# Detailed Site Plan Marlboro Gateway

# DSP-22019

STAFF REPORT

SUBJECT: Detailed Site Plan DSP-22019  
Type 2 Tree Conservation Plan TCP2-046-2022  
Marlboro Gateway

**Figure 1: Site Plan**

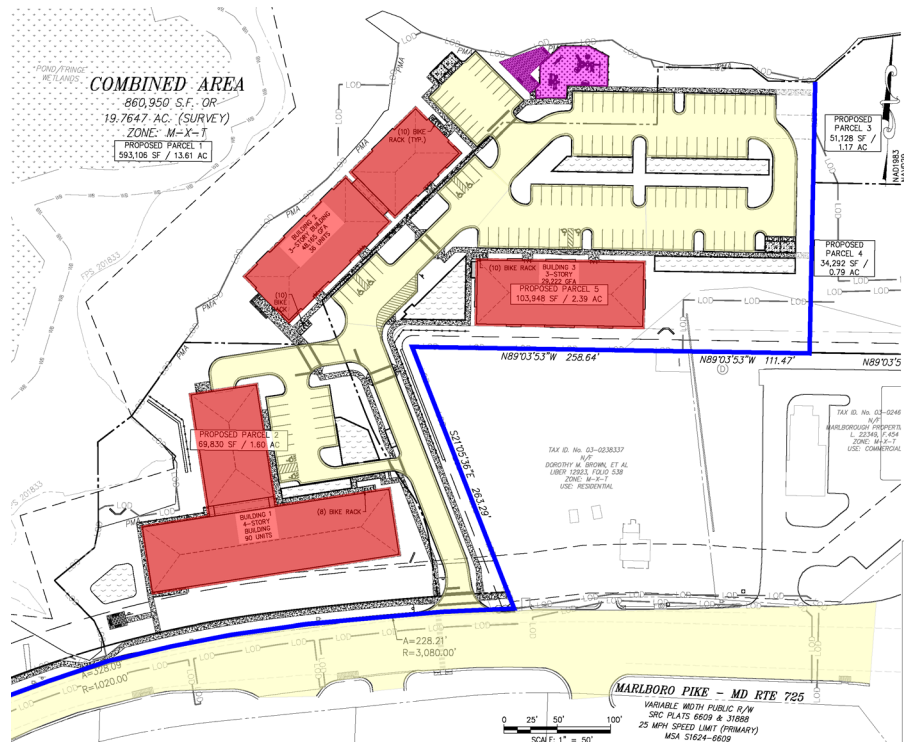
The site plan shows three retaining walls located near Buildings 1 and 2 to accommodate the steep topography of the site. These walls vary from 2 to 19.6 feet in height and are proposed to be constructed of modular concrete blocks. However, the detail for these retaining walls does not specify the color of the concrete blocks. A condition has been included herein, requiring that the color of the retaining wall blocks match the color of the masonry brick used in the buildings.

The detailed plan of the tot lot depicts engineered wood fiber as the surfacing of the play area. However, the cost estimate provided on the coversheet lists rubber surfacing. Staff finds that rubber surfacing is safer, more durable, and more desirable than engineered wood fiber surfacing. Therefore, the details shall be revised to specify rubber surfacing for the play area, prior to signature approval of the DSP.

The DSP also includes details for trash receptacles. The site plan, however, does not indicate the location(s) where these trash receptacles will be provided. At a minimum, trash receptacles should be provided near the picnic tables and the play area, and along the pedestrian paths close to building entrances.

The DSP proposes two seating areas for passive recreation. A small seating area, approximately 220 square feet in area, is proposed between Building 1 and MD 725. This seating area is accessible via a pedestrian path from both Building 1 and the public sidewalk fronting MD 725. Dense planting of evergreen and shade trees is proposed to shelter this seating area from the public street. However, this area is subject to nuisance noise levels due to proximity to MD 725 and should be removed. A second, larger seating area of approximately 930 square feet is proposed near the play area. This seating area provides seating benches and picnic tables. The surface of this seating area is proposed to be permeable pavement for which a detail has been provided in the DSP. The permeable pavement appears to be constructed of open pavers, which could be of concern for not being ADA-compliant. A note shall be added to the detail of permeable pavement, stating that the surface will be ADA-compliant. The site plan should also be revised to provide a detail for the proposed picnic tables.
